Republic of the Philippines
Department of Justice
BUREAU OF CORRECTIONS
NEW BILIBID PRISON

Muntinlupa City
BIDS AND AWARDS COMMITTEE
SUPPLEMENTAL BID BULLETIN NO. 1

**CONSTRUCTION OF LEGAL HEARING FACILITY WITH RELATED
EQUIPMENT AT IWAHIG PRISON AND PENAL FARM (IPPF)**
ITB NO. 2026-009
28 April 2026

Figure 1. Reference Detail of Column 2

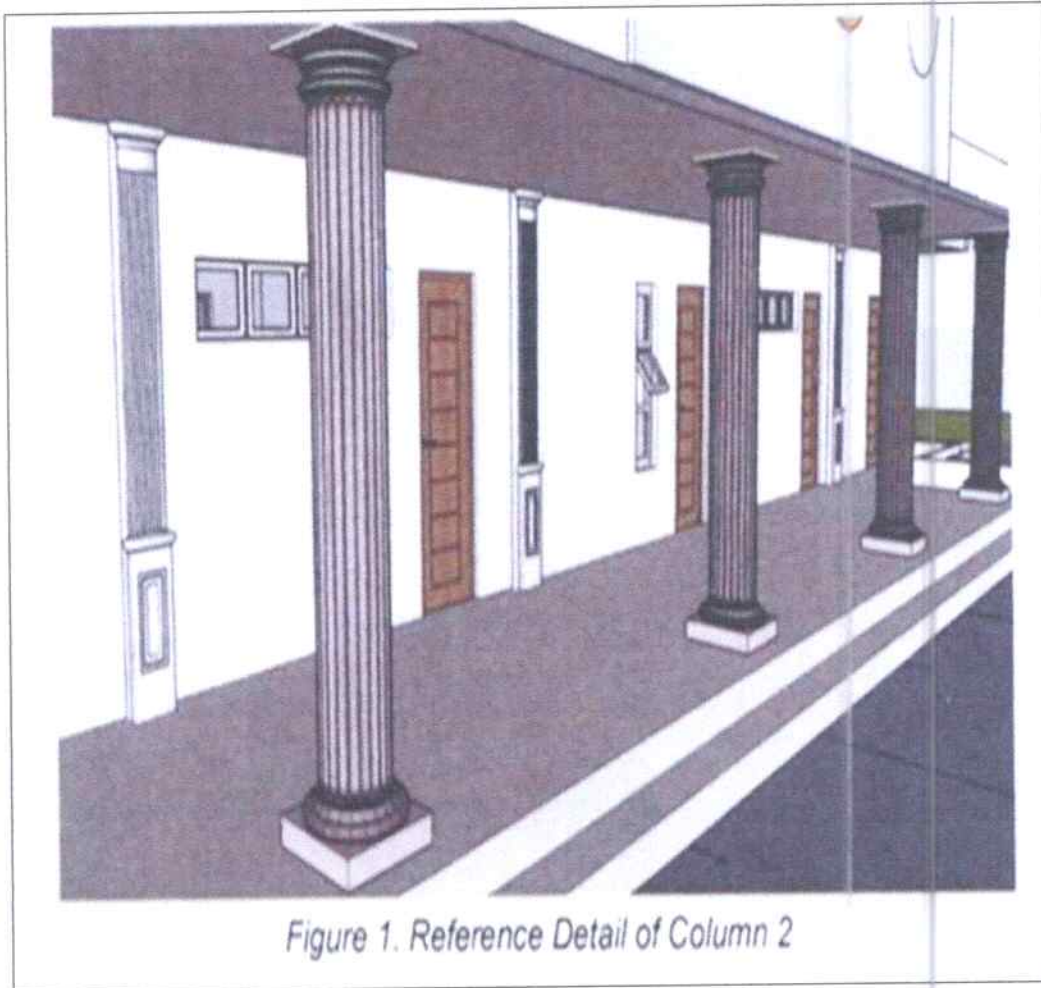
Query/Clarifications	Response/Answer
<p>8. CHB Wall Types</p> <p>Clarification and detailed plans indicating where CHB 6 and CHB 4 are to be used</p>	<p>Exterior Walls -6" CHB, Interior Wall Partition - 4" CHB</p>
<p>9. Parapet Wall Details</p> <p>Complete details and specifications for parapet walls.</p>	<p>Parapet Walls shall be 4" CHB to be installed on a stiffener beam IB-1.</p>
<p>10. Columns (C-2)</p> <p>Detailed Drawings and Dimensions for column capitals</p>	<p>Diameter of the Column is 0.45m. Please refer to the perspective of the plans for the detail reference of the columns.</p>

Figure 3 Furniture Plan

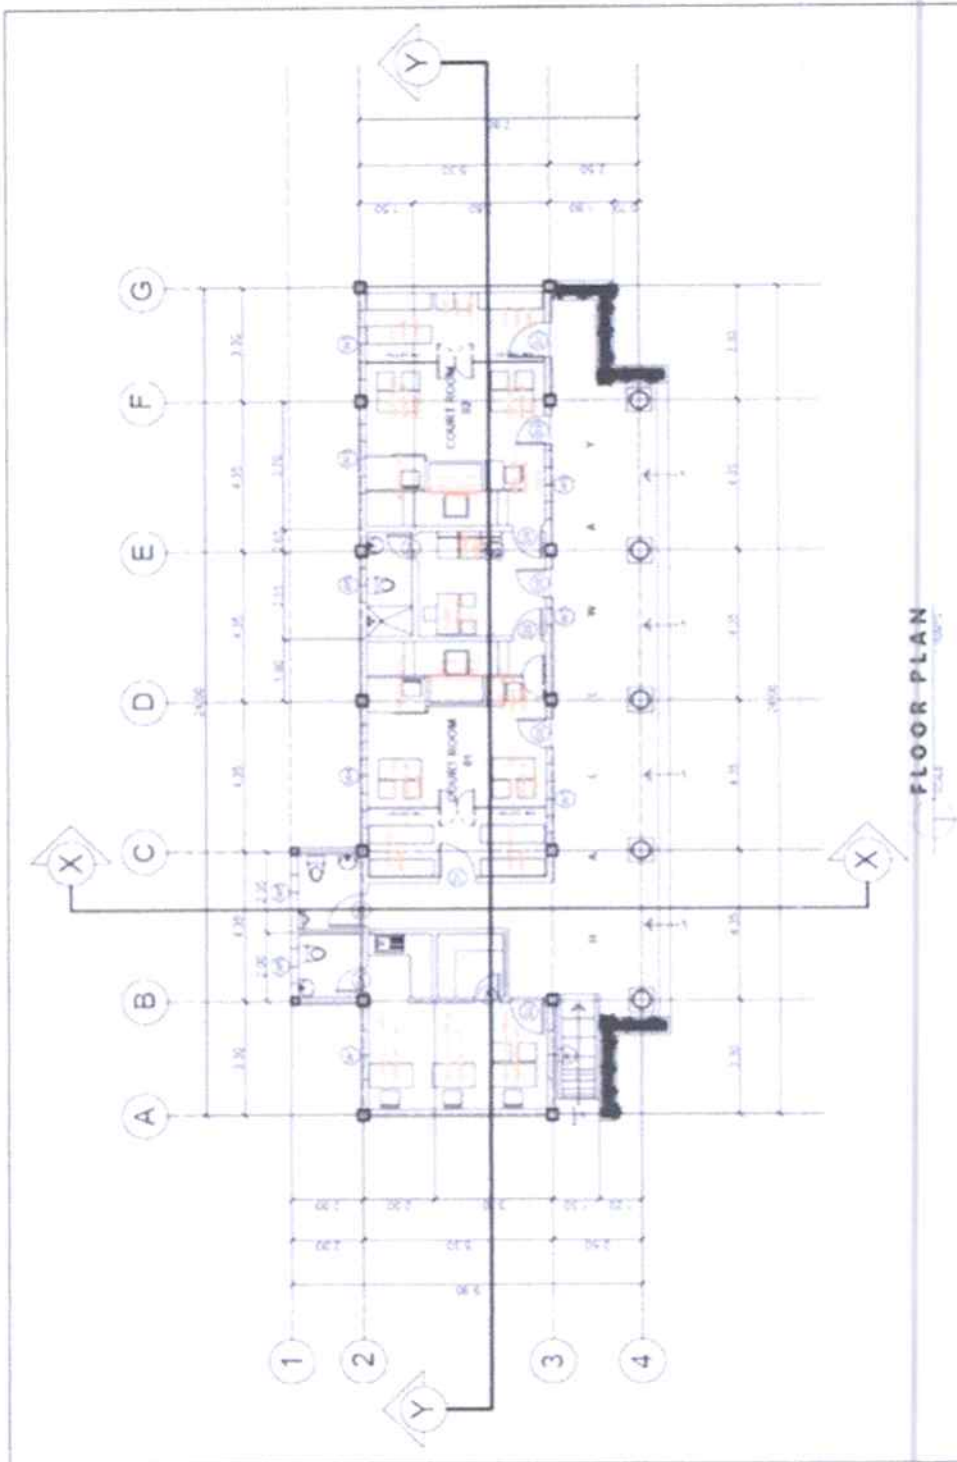
Query/Clarifications	Response/Answer
<p>13. Upholstered Sofa Detailed dimensions of Sofa</p>	<p>Sofa's Dimension — 0.8m W x 1.8m L</p>
<p>14. Furniture and Accessories Scope Clarification whether the quantities and specifications under "Furniture and Other Accessories" in the Scope of Works are included in the contract, or if the furniture shown in the floor plans shall be considered.</p>	<p>Yes, all furniture items are included in the Detailed Estimate, although they are quantified on a lump sum basis. Please refer to the figure below for guidance.</p>

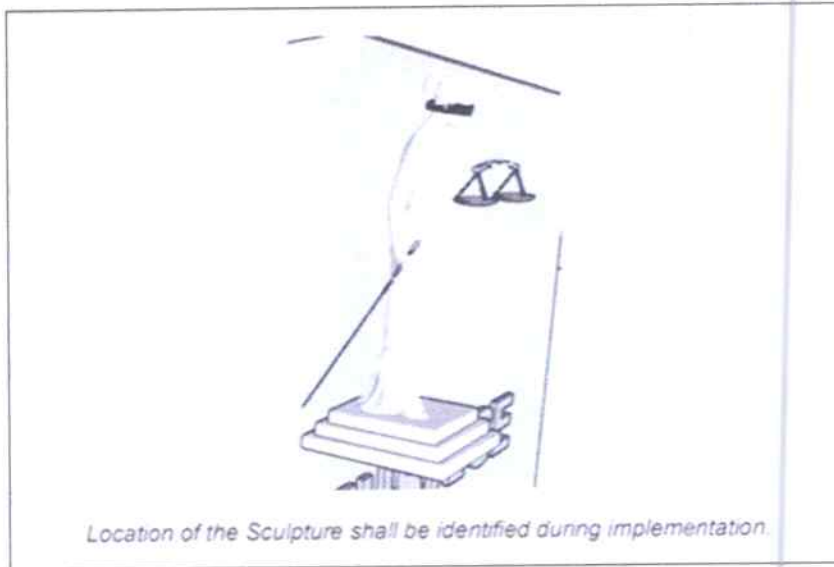
Query/Clarifications	Response/Answer
<p>15. Lady Justice Sculpture</p> <p>To clarify the required Specifications, particularly whether the finish shall be painted or otherwise specified.</p>	<p>Lady Justice Sculpture is included in the Detailed Estimate together with the Stainless Steel Letters quantified on a lump-sum basis under item in "Furniture and Accessories Scope". This shall be stainless Steel with dimensions as follows:</p> <ul style="list-style-type: none"> • Height - 1.46m • Width - 0.35m • Depth - 0.3m
